RE: Application for Permit to Drill: Utah 5-1142, Utah 20-1183, Utah 17-1177, Utah 18-1179

DIVISION OF OIL, GAS AND MINING
APPLICATION FOR PERMIT TO DRILL
STATEMENT OF BASIS

OPERATOR: ConocoPhillips Company
WELL NAME & NUMBER: Utah 17-1177
API NUMBER: 43-007-31155
LOCATION: 1/4,1/4 SESE Sec:17 TWP: 15 S RNG: 9 E 490 FSL 550 FEL

05-06 ConocoPhillips Utah 17-1177
Casing Schematic

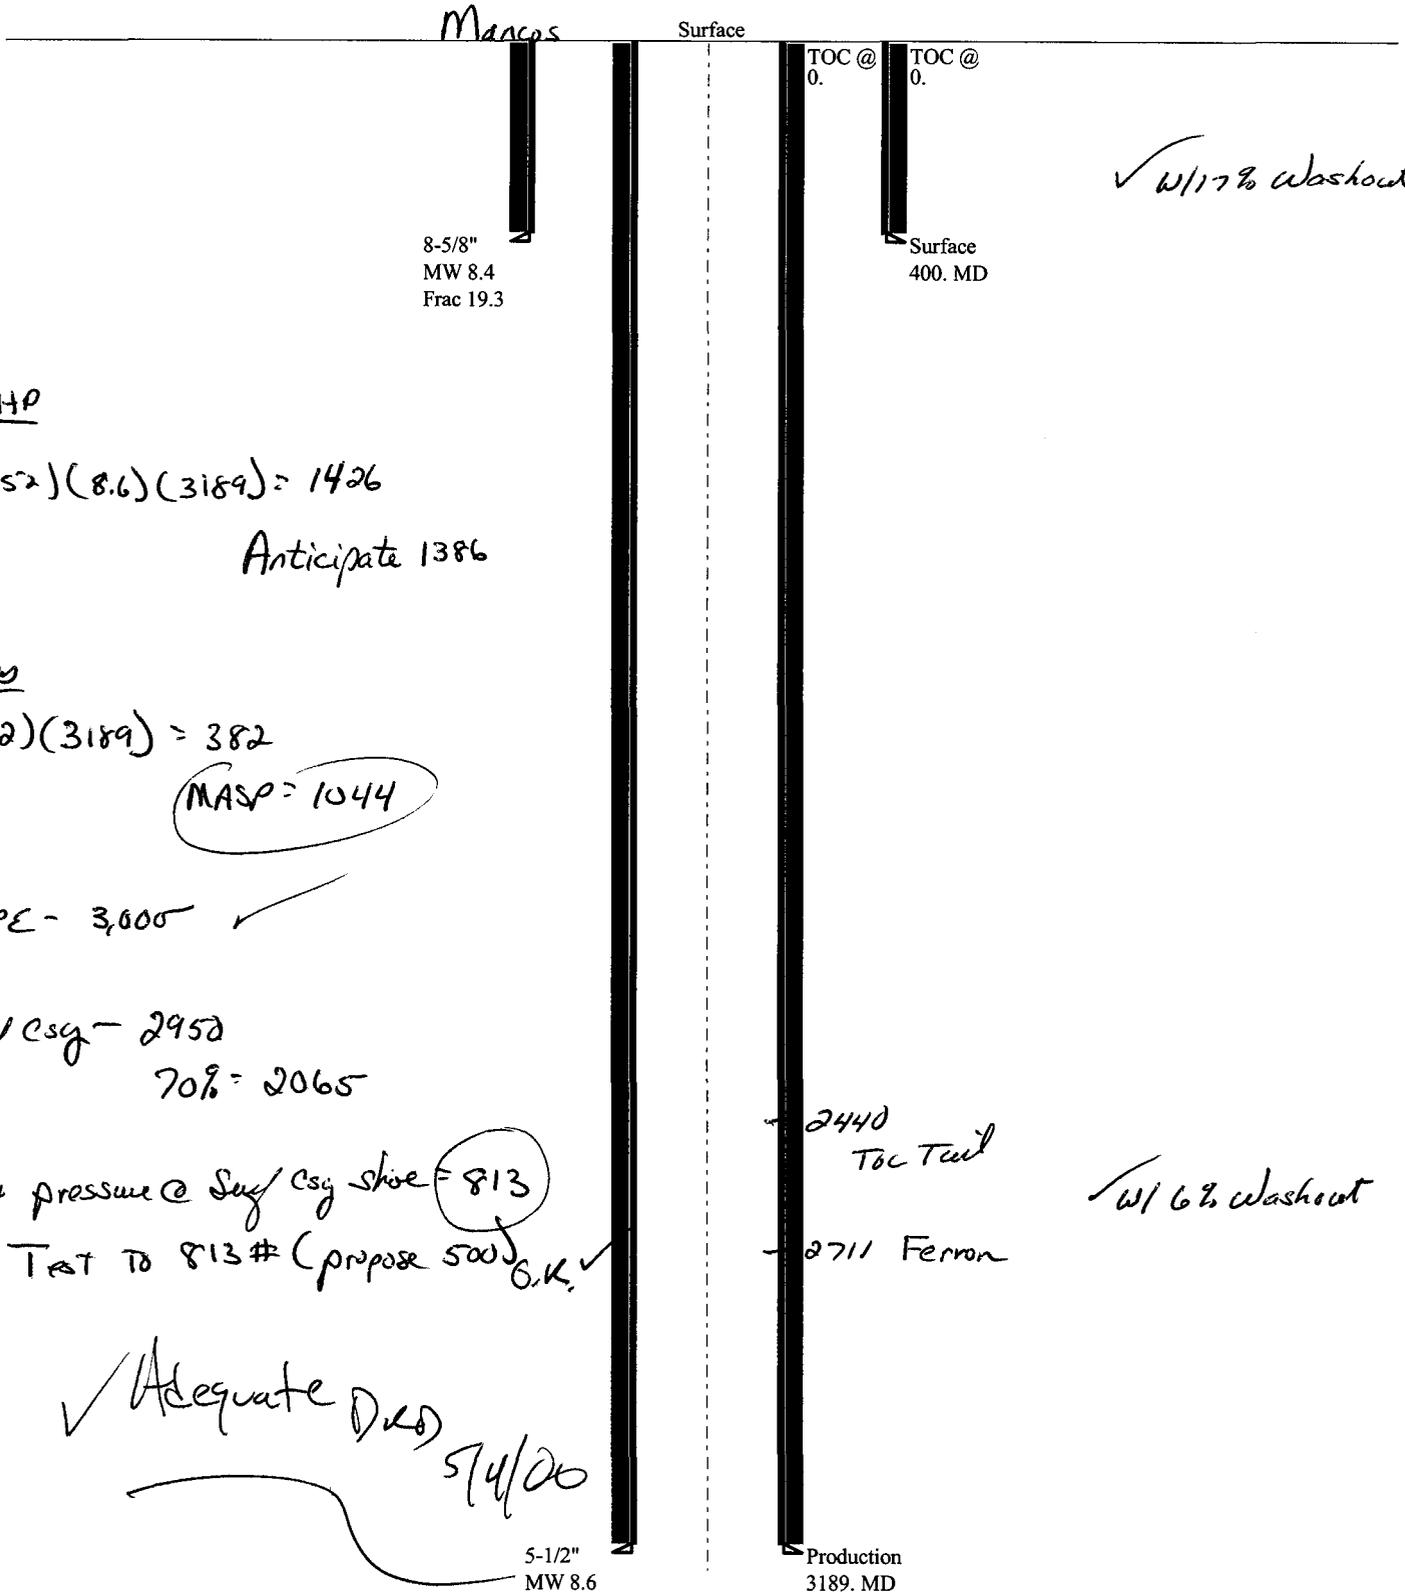
8-5/8"
MW 8.4
Frac 19.3

$$(0.052)(8.6)(3189) = 1426$$

Anticipate 1386

$$(0.12)(3189) = 382$$

MASP = 1044

BOPE - 3,000 ✓

Surf csy - 2952

70% = 2065

Max pressure @ Surf csy shoe = 813

Test to 813# (propose 500) G.K. ✓

✓ w/ 6% Washout

✓ Adequate D.K. 5/4/00
